RE: Blythe Energy Transmission Line Project Request for Approval of Insignificant Change (99-AFC-8C)

**Request for Approval of Second
Insignificant Project Change
(99-AFC-8C)**

**Blythe Energy Project
Transmission Line
Minor Route Realignment and
Change in Laydown Yards**

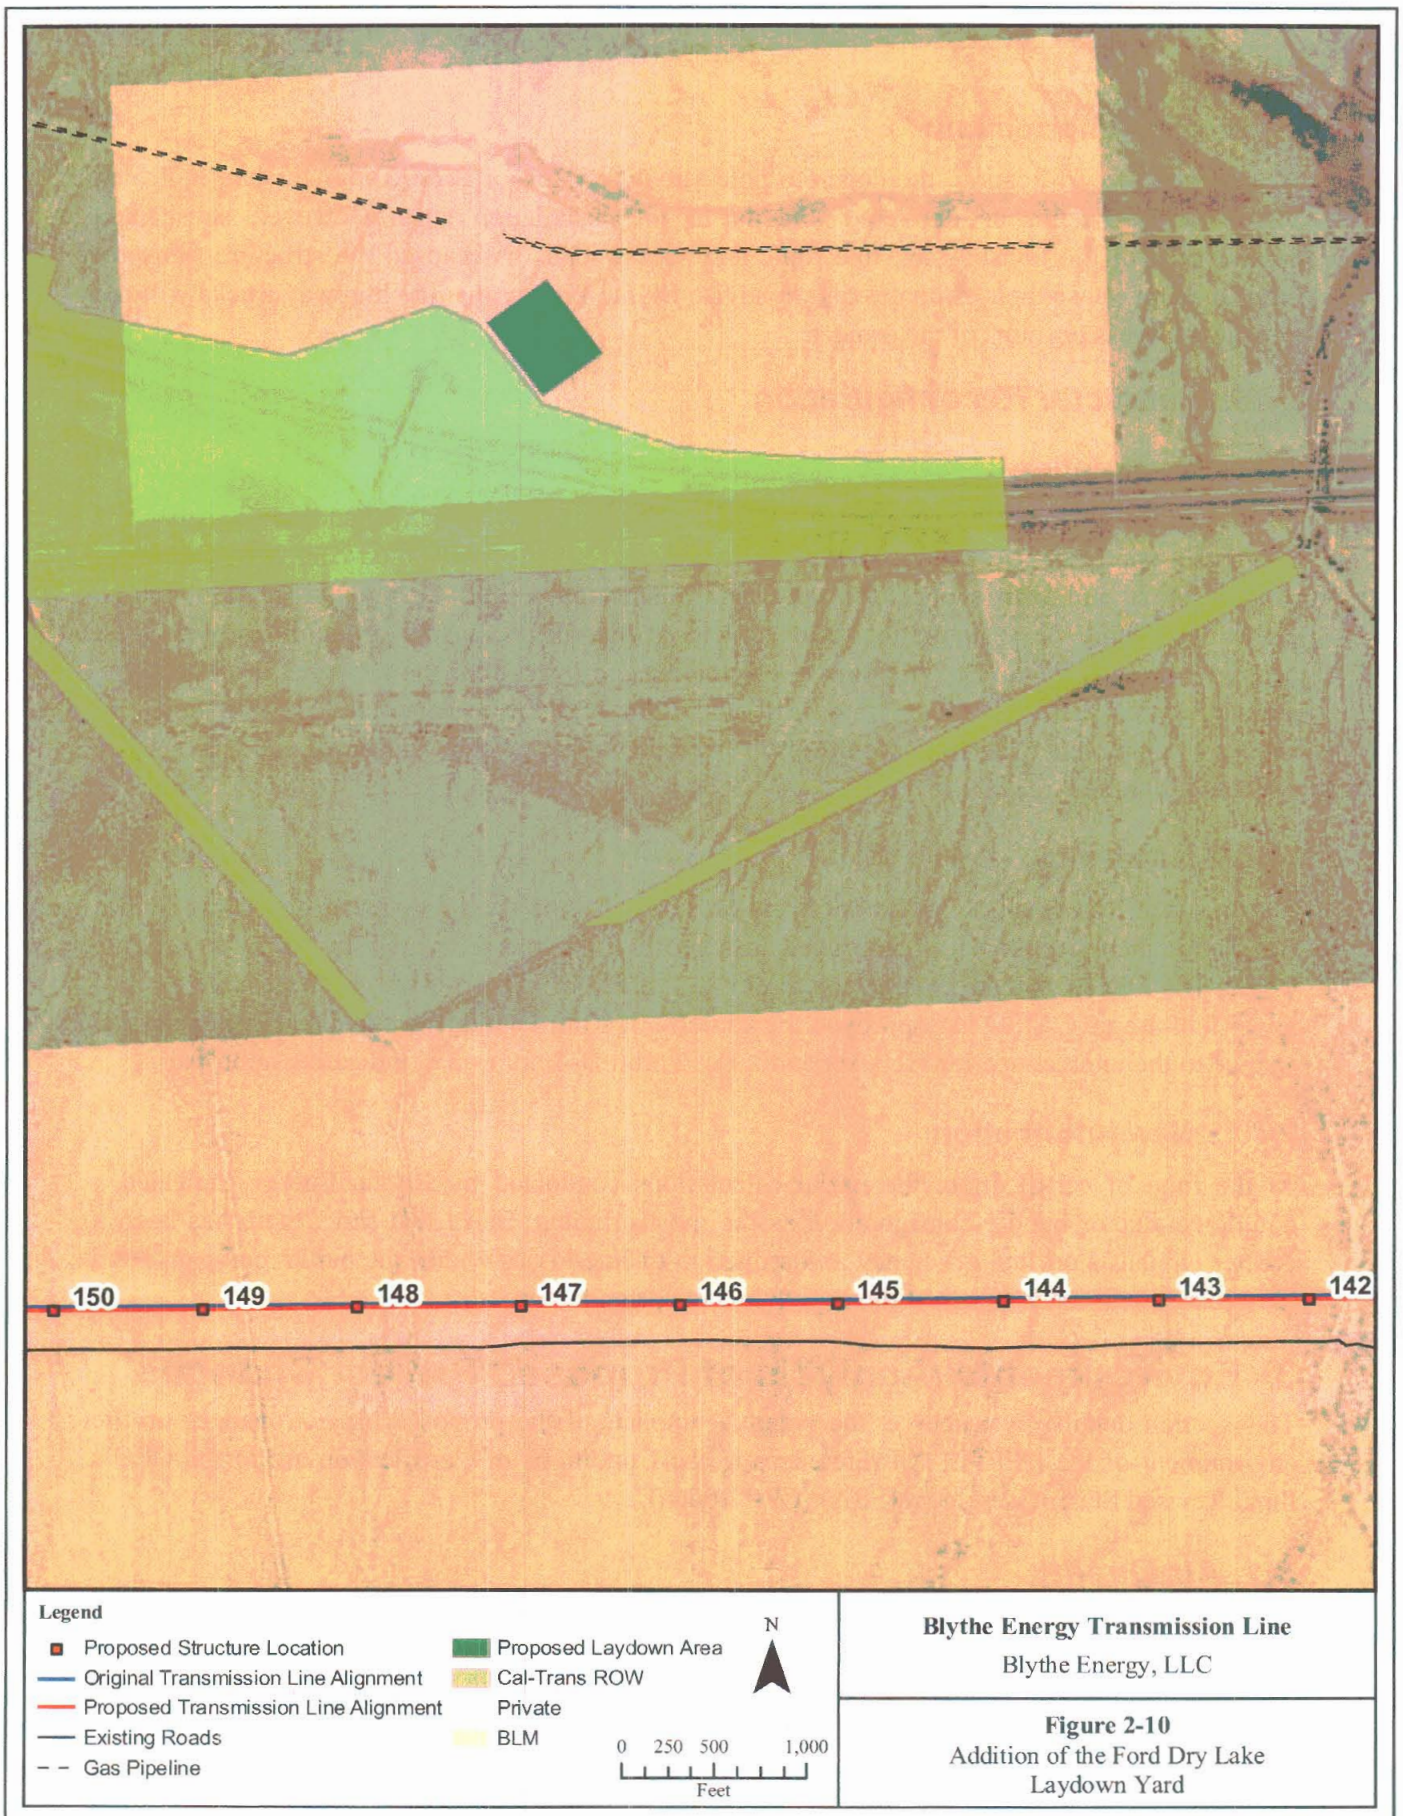
Figure 2-10 illustrates the proposed 5-acre Ford Dry Lake Exit laydown yard. The area is presently used as an informal layover area by truckers and campers; it is without vegetation and is heavily littered. It is adjacent to the Caltrans ROW on the south and west of the laydown area. Blythe Energy would collect and remove trash and garbage from the area and erect temporary fencing around the perimeter with a gate to allow truck access. The fencing would be equipped with desert tortoise exclusion fencing (see Section 3.2, Biological Resources). There is an existing access road that continues past the proposed laydown yard and accesses a natural gas pipeline, the Ford Dry Lake area, and the McCoy Wilderness trailhead. No additional access road construction is proposed.

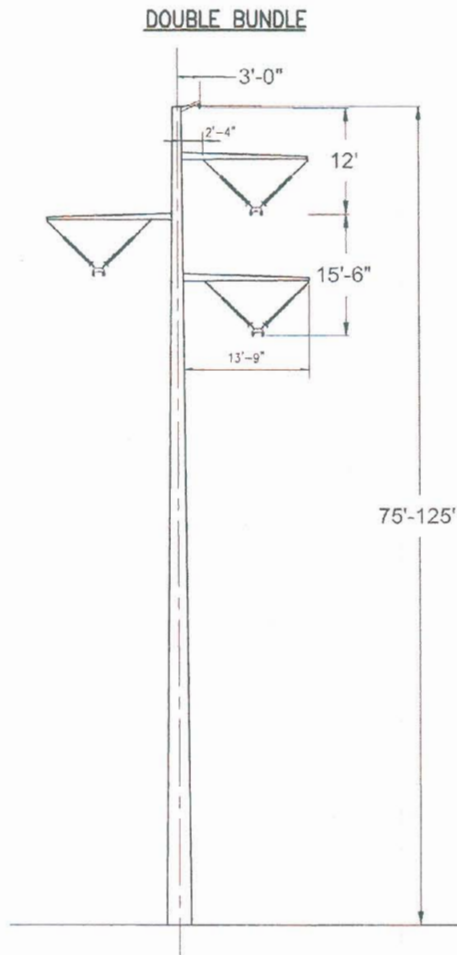
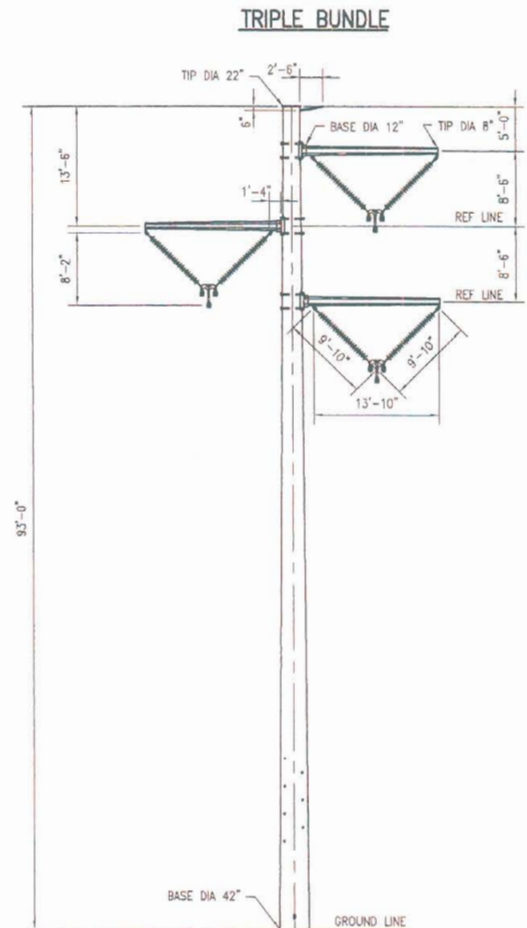
Blythe Energy proposes to construct the BEPTL with a three-conductor bundle rather than the previously approved two-conductor bundle. See Figure 2-11 for a detailed comparison drawing of the original and additional proposed design. This design will not change the location, height, embedment depth, or configuration of the structures, but will increase their diameter by 15 to 20 percent over the original design. The sag calculations performed for the I-10 crossings at Blythe and at Hayfield Road are not altered by the addition of the third conductor to the bundle. No change in disturbance footprint would result from the addition of an additional conductor to the conductor bundle.

REVISED
POLE ALIGNMENT

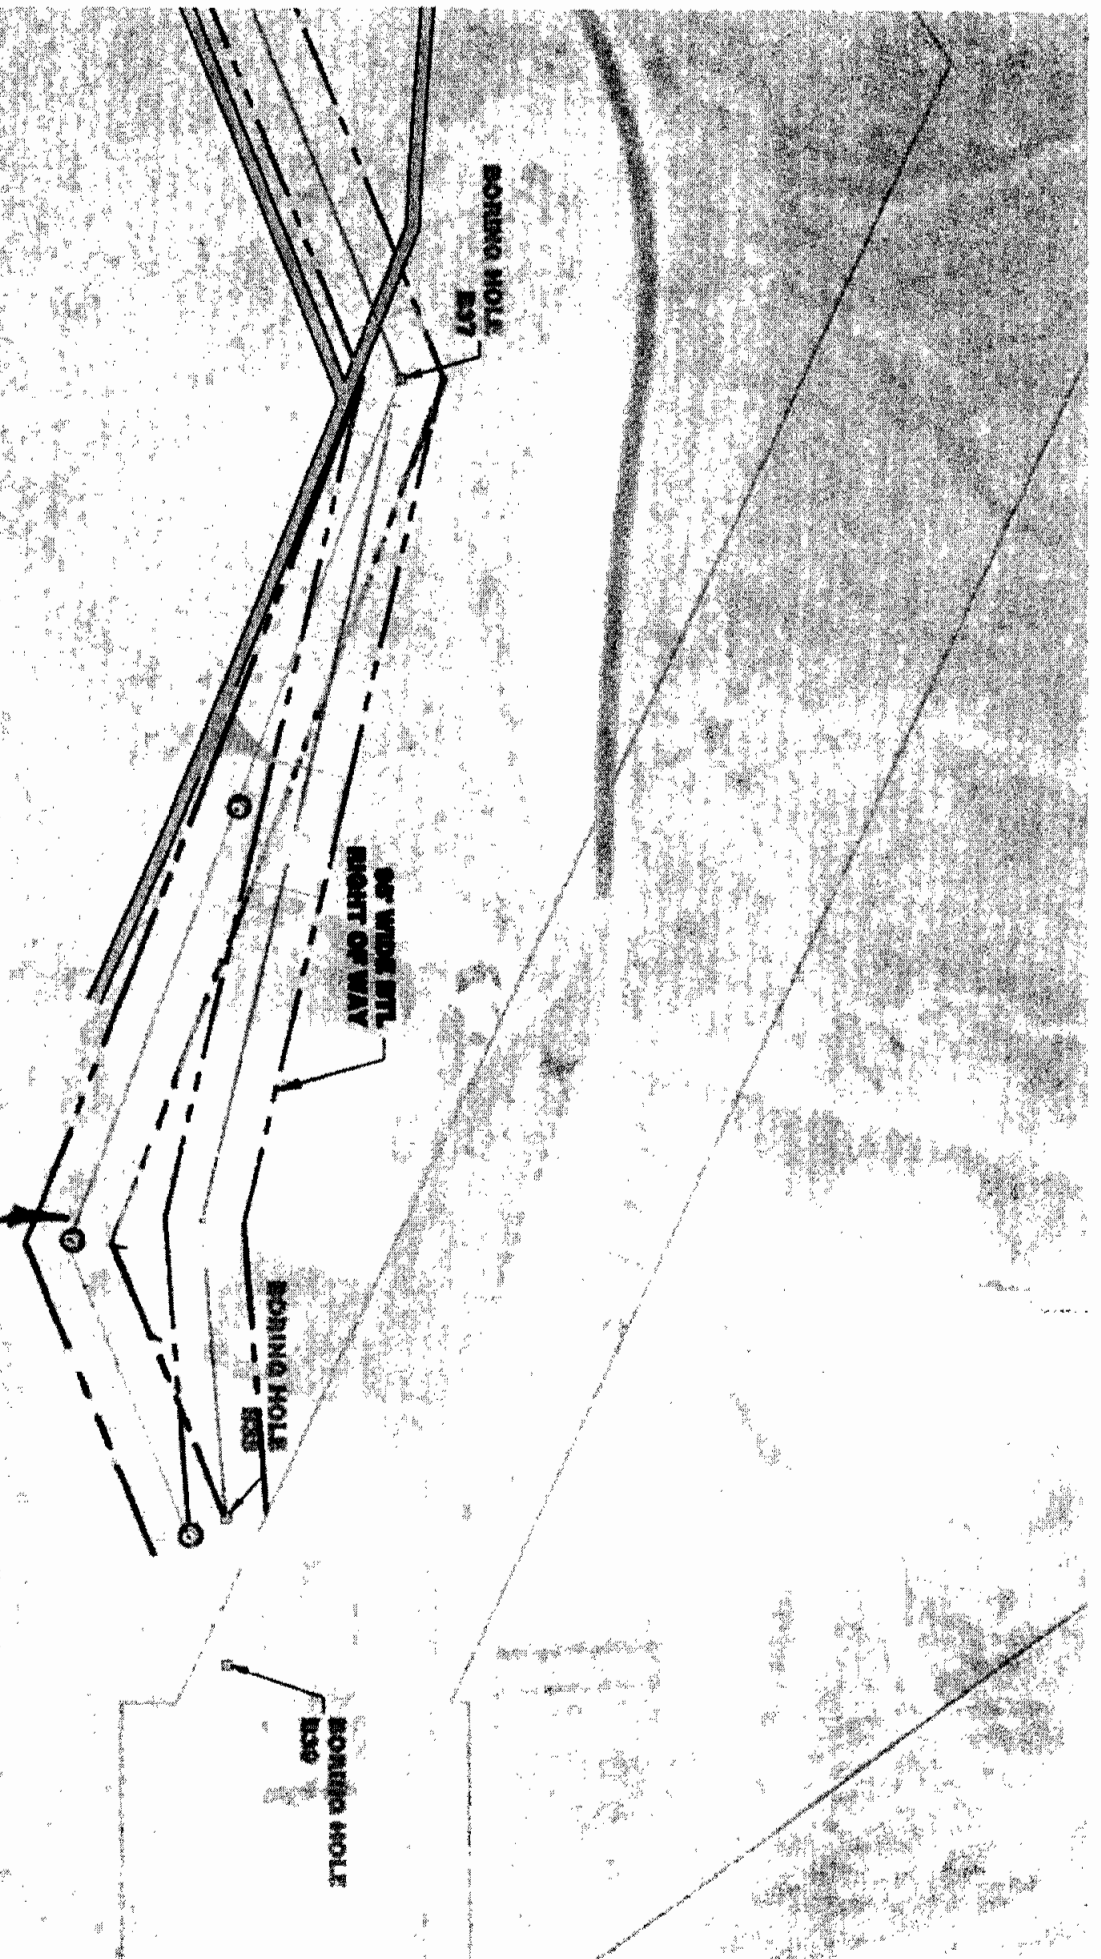
Lynn,
It was good to speak with you yesterday. As discussed, I think we can re-align poles 431 through 434 as you have requested. However, I am looking at my notes and the images and coming up with a few questions. Perhaps it would facilitate the process if you could draw the preferred route on a blow up of the sheet Mike sent you and either e-mail it or fax it to me at (208) 788-0525? I think this may save
